Response to Submissions and Amended Proposal

Stadium Australia Renewal
15 Edwin Flack Avenue, Sydney Olympic Park
SSD DA 10342

Submitted to Department of Planning, Industry
and Environment

20 December 2019 | 2190435

Figure 3 Revised temporary construction vehicle route during the Royal Easter Show

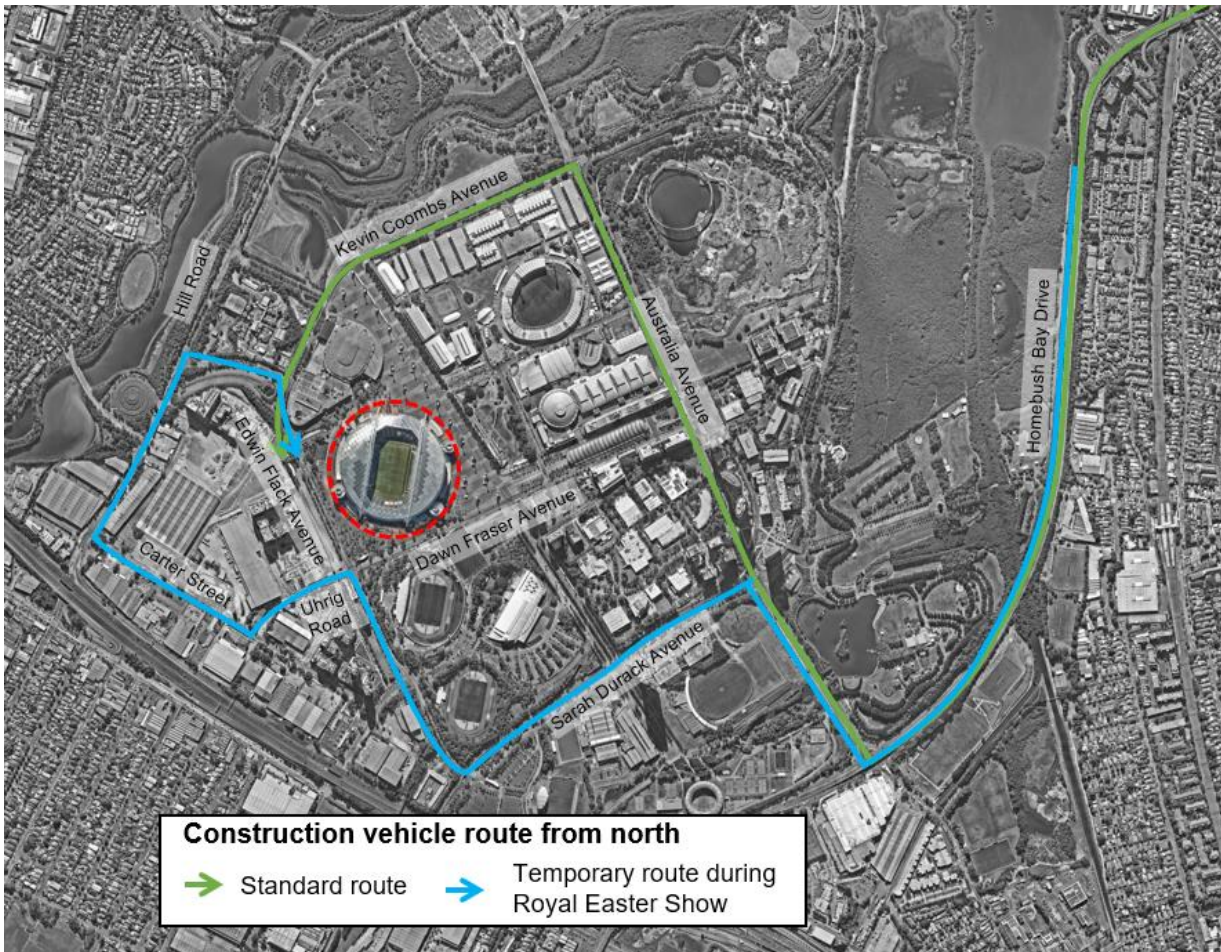
DPIE and SOPA have sought to clarify how the proposed temporary construction compound will impact on pedestrian movements to and from the Royal Easter Show and how vehicle construction routes may be impacted during the Royal Easter Show when special road closures are in effect.

- During the Royal Easter Show only one construction vehicle route will be impacted from road closures, being vehicles arriving from the north and travelling along Kevin Coombs Avenue. In this instance, a temporary construction route will be imposed so that vehicles use Australia Avenue and Sarah Durack Avenue to access the construction site (see **Figure 3**). Importantly, no vehicles will use Olympic Boulevard during the construction process, ensuring the Plaza and Aquatic bus terminals can remain open and unaffected during the Royal Easter Show and other events.

Figure 4 Event noise contours illustrating concert noise decreases compared to existing Stadium Australia

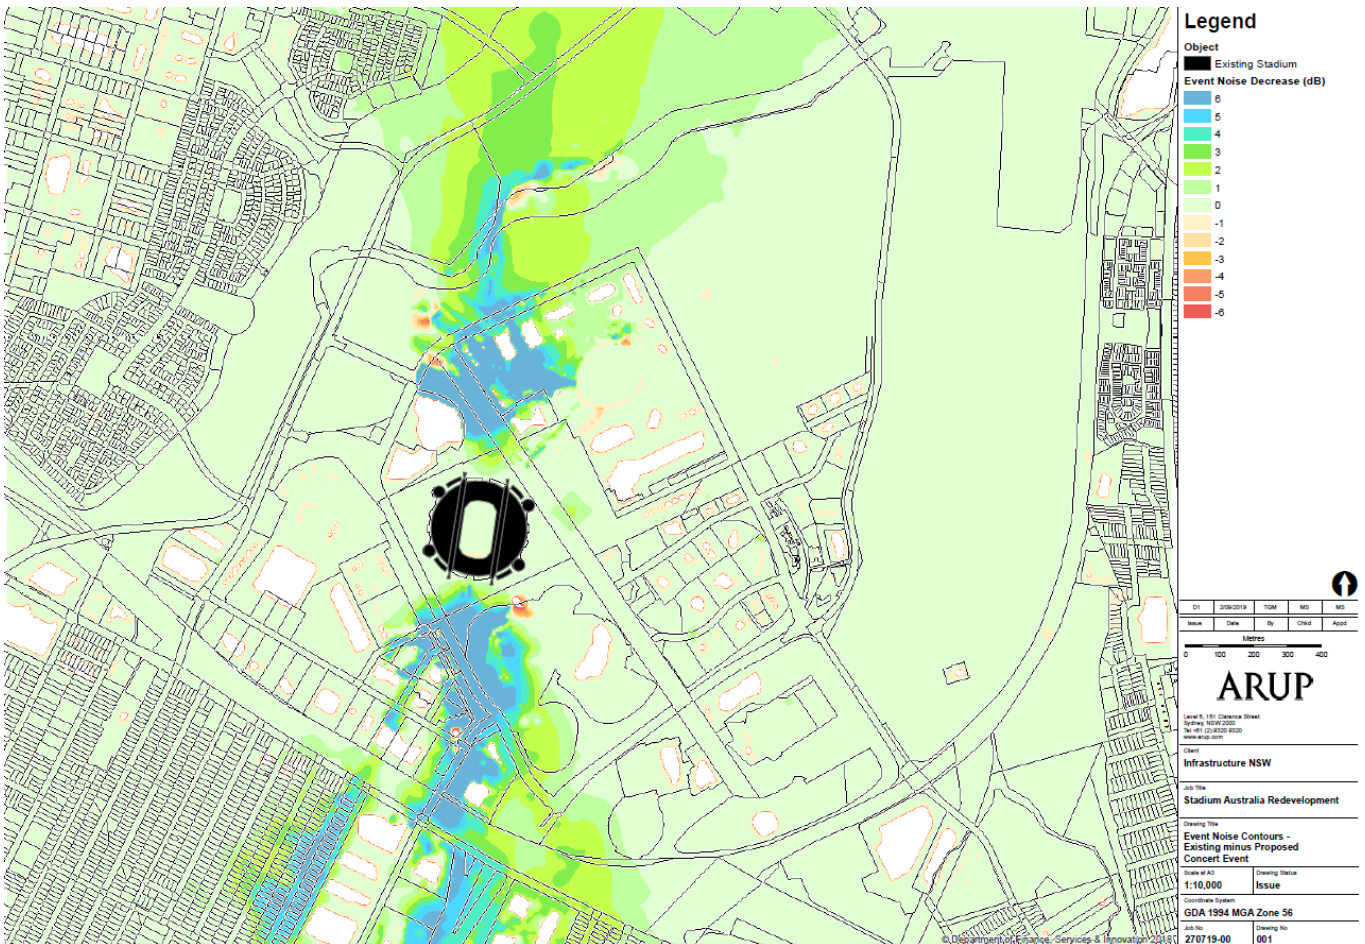
DPIE has requested a revised Noise and Vibration Assessment (Revised NVIA) clarifying a number of detailed modelling and assessment requirements nominated by the NSW EPA. The revised Assessment has been prepared by Arup and submitted at **Appendix C** of this report, and discussed in detail in the responses at **Appendix A**.

As there is no change to the type, scale or frequency of events to take place at Stadium Australia and no significant modifications to the existing façade of the stadium, no significant increase in event noise is predicted. Minor reductions in overall noise emissions from concert events and sporting events are predicted for most operational scenarios at most receivers as a result of higher-tiered seating, resulting in more shielding from event noise within the stadium, and an overall reduction in seating capacity. This is illustrated in **Figure 4**, which notes that the greatest benefits in terms of noise reduction would occur to receivers located along the north-south axis of the existing stadium as a result of the increased seating tiers.

It is noted the Carter Street DCP and SOPA Master Plan include specific planning requirements for new residential and other sensitive receivers to ensure that buildings are designed to mitigate against the effects of event noise and to ensure that property owners and residents are aware of the potential for noise generation associated with events. Although these receivers do not qualify for consideration against the numerical noise criteria from the venue, the results of the modelling does show that noise levels at these receivers will generally decrease as a result of the proposed upgrade.
